Docket No.: 71-9325 (HI-STAR 180 Model)
TAC No.: L24753
Reference: 1. NRC Letter (Saverot) to (Hinojosa) dated December 19, 2013
2. Holtec Letter 1553036-NRC, dated September 18, 2013
3. Holtec Letter 1553034-NRC, dated May 31, 2013

Subject: Response to Request for Additional Information on HI-STAR 180 Transport Cask License Amendment Request 9325-1

Response to Request for Additional Information (2nd Round RAIs)
Holtec International
Docket No. 71-9325
HI-STAR 180 Transportation Package – LAR 9325-1

Figure 4-7.1: Loading-Unloading Characteristics of O-Ring Seals

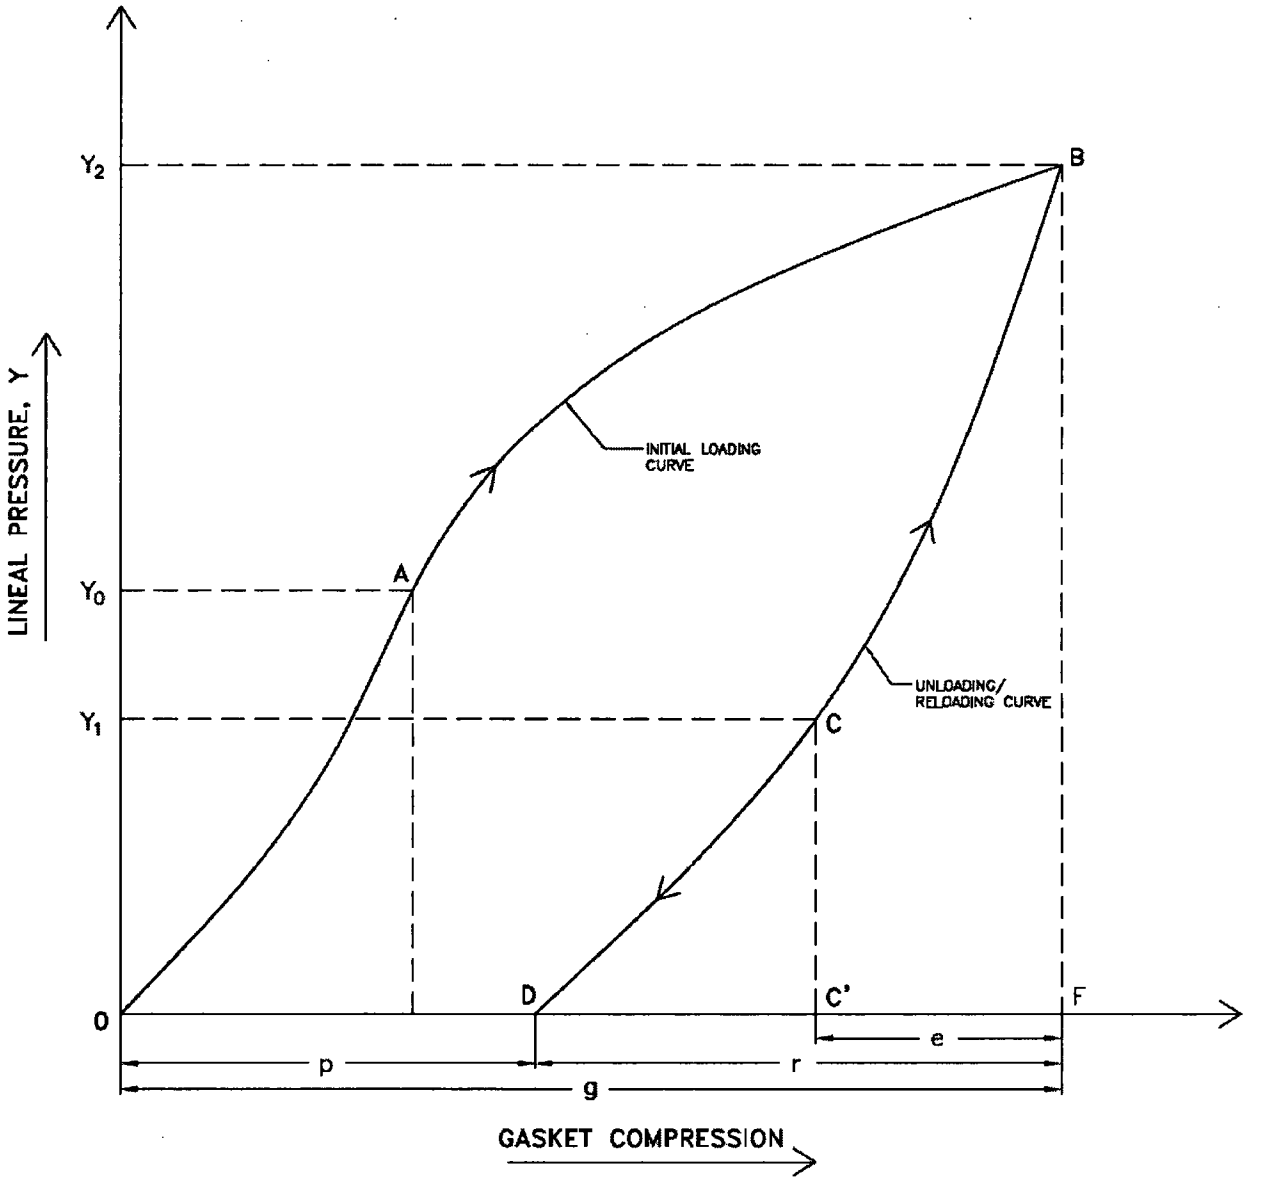
4.7 Address the following relative to the "useful" spring-back in association with the seal design and the ability of the closure lid seals to remain leaktight under all hypothetical accident events.

a. Define the "useful" spring-back to maintain leaktight closure lid seals in the SAR.

b. Provide justification for the numerical value of 0.01 inches for "useful" spring-back. Address how the spring-back of 0.03 inches that was used in the American Seal & Engineering "Seal option 1" design does not meet the definition of "useful" spring-back.

c. Provide clear and complete documentation in Section 2.7 of the SAR to show that, based on the structural analysis, the closure lid seals for the American Seal & Engineering "Seal option 1" and the Technetics "Seal option 2" will remain leaktight under all hypothetical accident events based on the "useful" spring-back, as well as the associated margin for these analyses.

d. Explain how the closure lid seals in the American Seal & Engineering "Seal option1" and Technetics "Seal option 2" have been designed to provide the minimum "Useful" spring-back required in Table 2.2.12 of the SAR and how this can be concluded from the design drawings provided.

We agree that a clear distinction between the terms "total spring-back" and "useful spring-back" is necessary to avoid incorrect interpretation of the results. For this purpose, Figure 4-7.1 below illustrates the loading/unloading/re-loading curve for a typical O-ring gasket. The terms noted in the figure's legend are used in the explanation below to facilitate presentation.

a) The term "useful" springback is defined as the amount that the seal can unload without the leakage rate exceeding the required value. In Figure 4-7.1 below, the "useful" springback is the distance between points F and C', denoted by the letter e in the figure. In the prior submission, the term "Spring Back at Complete Decompression" was used which represents the amount that the seal diameter recovers when completely unloaded, i.e., the total springback. In the figure below, the "Spring Back at Complete Decompression" is the distance between point F and the end point (i.e., zero load point) of the unloading curve, D. This distance is denoted by the letter r in the figure.

(vi) In order to maintain joint seal, it is necessary that the compression of the seal lie between points F and C'; i.e., in the useful recovery range.

(vii) The total recovery, denoted by letter r, is substantially greater than the elastic (useful) recovery, denoted by letter e.

The structural analyses reported in SAR sections 2.6 and 2.7 conclude that the seal will remains fully seated (at point B in Figure 4-7.1) after all of the analyzed Level A and Level D accidents. In other words, the seal springback at the end of the analyzed accident is *zero*. Thus none of the elastic springback available in the joint (.01 inch in the selected seal designs) is used or needed. While the American Seal & Engineering "Seal option 1" design has a *total springback of 0.03" (r = .03 inch in Figure 4-7.1)*, the evaluation of the seal performance should be based on the *useful springback, denoted by letter e.* SAR sections 2.6 and 2.7 have been revised to provide the necessary clarification.
